TANK 4 AND LEACHATE TRANSMISSION SYSTEM REPORT
CONSTRUCTION QUALITY ASSURANCE (CQA)

EVENT REPORTS AND CORRECTIVE ACTIONS

SUPPLIER DEVIATION DISPOSITION REPORT

Subcontract No.: S013213A00 ERDF Cells 9 & 10 CQA

Drawing No. 0600x-DD-C0475

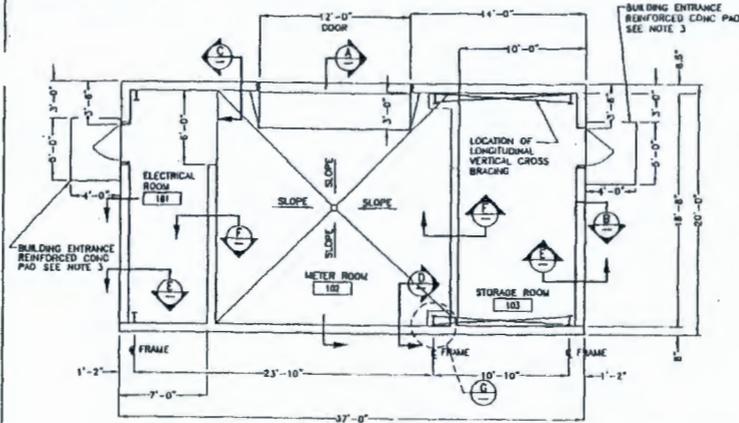
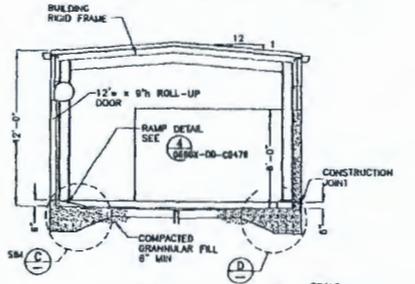
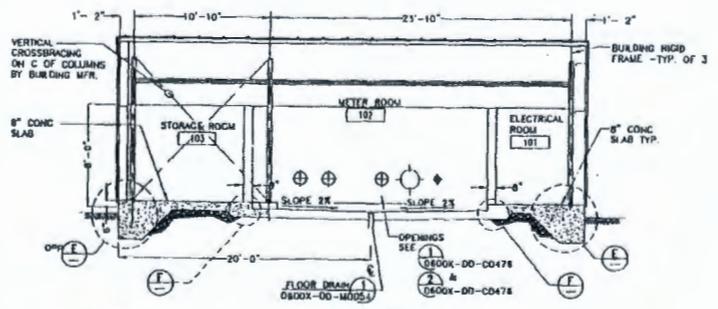
12. Deviation description:

- 1) Add #7 dowels 4'-6" @ 10" O.C.
- 2) Delete curb between footing and wall.

This eliminates two cold joints which could become a potential safety hazard. Also eliminates the need to extend 10' VTS bar out of the footing when the slab is poured. This would become an immediate safety hazard that would be eliminated. Secondary containment would be achieved by the existing 8' wall

Added value to WCH at no cost, no schedule change.

20. WCH Disposition Statement including Justification (Attach extra sheets, sketches, etc., as necessary)			
THE curb shall be part of monolithic slab to provide containment. The PROPOSED DEVIATION ADDS A JOINT AND DOES NOT PROVIDE CONTAINMENT
